**DEVIATION REQUEST  
AND DECISION FORM IN  
ASSOCIATION WITH  
A REQUEST FOR A PUD  
MODIFICATION FROM  
THE ECM**

Project Name :	MEADOWBROOK PARK
Schedule No.(s) :	5408008002, 5408403001, 5408001029
Legal Description :	TRACT A 24/94 BUSINESS PARK FIL NO 1; TR I MEADOWBROOK CROSSING FILING NO 1, AS AMENDED BY AFFIDAVIT OF CORRECTION REC #218068301; & TRACT IN SE4 SEC 08-14-65 AS FOLS, BEG AT A PT ON N BDRY LN OF SD SE4 WHENCE THE E4 COR BEARS S 89<33' E 2023.0 FT, TH S 89<33' E 598.6 FT, S 33<35' W 508.5 FT, S 56<25' E 30.0 FT, S 37<48' W 375.0 FT, S 17<09' W 148.2 FT, N 02<16' W 417.0 FT, N 06<38' E 358.0 FT, TH N 17<04' E 15.7 FT TO POB, EX THAT PT PLATTED TO CLAREMONT BUSINESS PARK FIL NO 2, EX THAT PT CONV TO D.O.T. FOR R/W BY REC # 205077959

**PROPOSED MEADOWBROOK PARK PUD PRIVATE ROAD CROSS SECTIONS**

**STANDARD COUNTY URBAN LOCAL CROSS SECTION:**

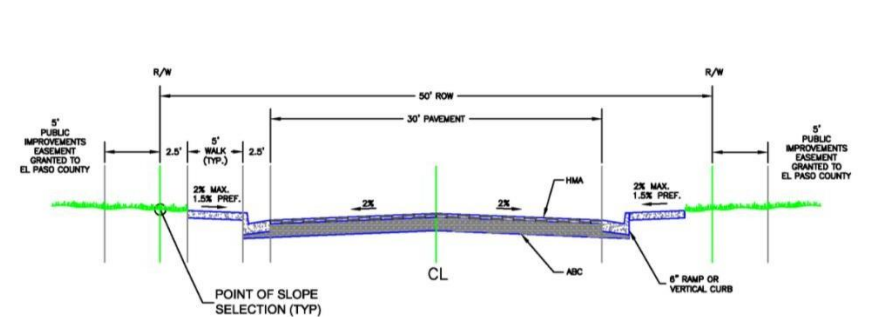
- Change of pavement width from 30 feet EOP (Edge of Pavement) to EOP to 29 feet EOP to EOP

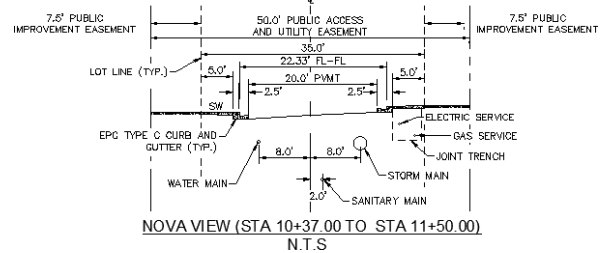
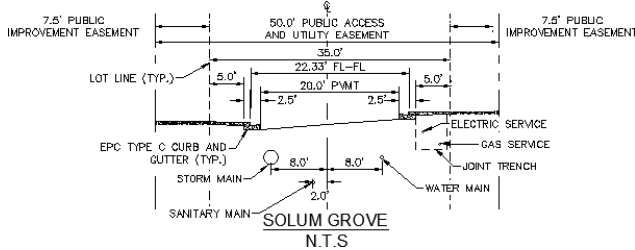
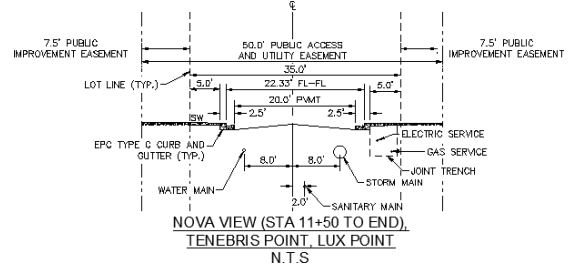
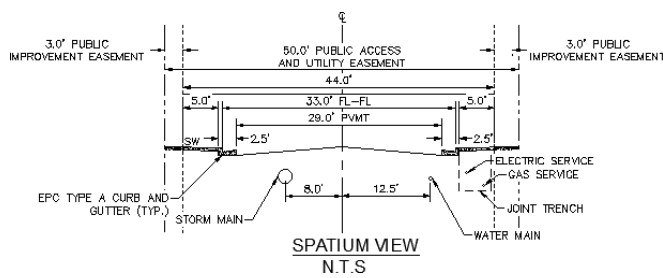
**Deviations Requested from Urban Local Roadway Section:**

**Deviations Requested from Urban Local (Low Volume) Roadway Section:**

- Change of pavement width from 24 feet EOP (Edge of Pavement) to EOP to 20 feet EOP to EOP
- Change of crowned pavement to superelevated roadway section for certain portions of roadway to facilitate drainage
- Change of lane width from 12 feet to 10 feet
- Change of centerline radius from 100' to 40' on Solum Grove Road (for Emergency Access)

### Fire and Life Safety Division Approval/Explanation Letter

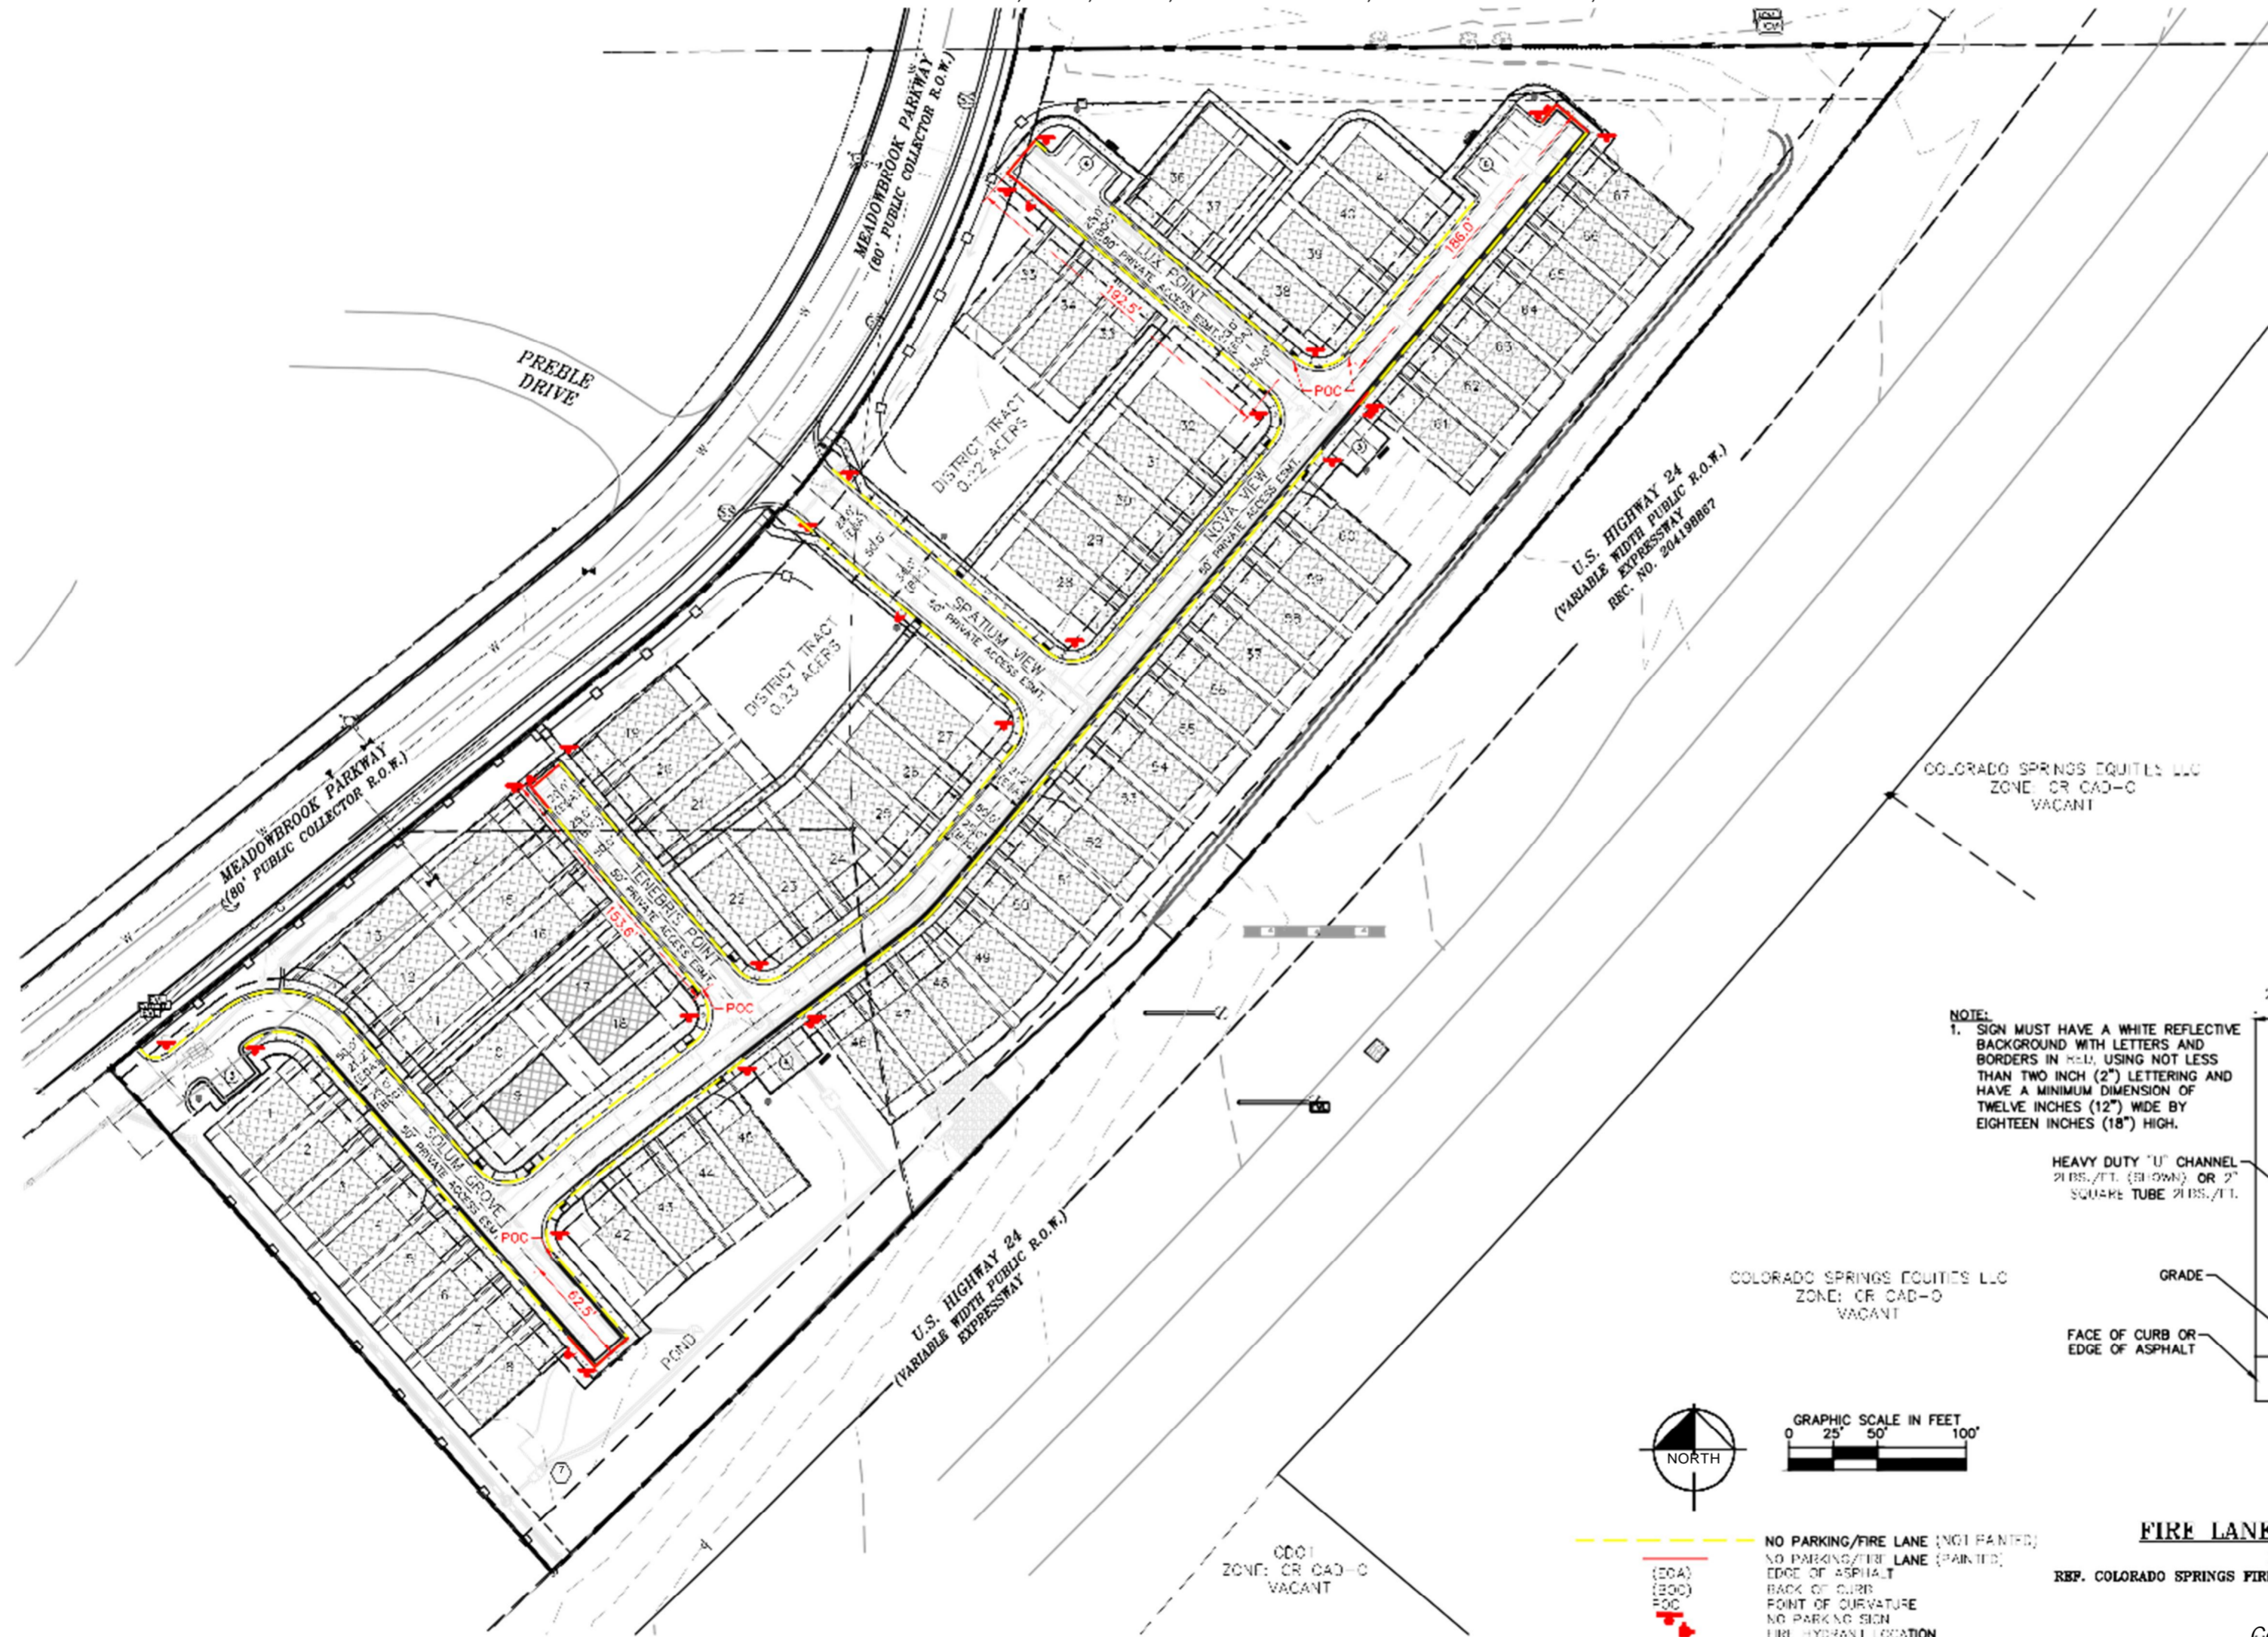
CHFD has reviewed the Planned Unit Development with the development team and have approved the following details:

- ✓ The shown road widths are acceptable and fire lanes that will be provided will give us the access that we need. Turning radius and access are within our apparatus specs.
- ✓ Dead end lengths are acceptable per our CHFD Amendments as fire hydrants will be added to give us adequate flows and connections.
- ✓ KNOX box gate access is allowed for emergency access and approved.
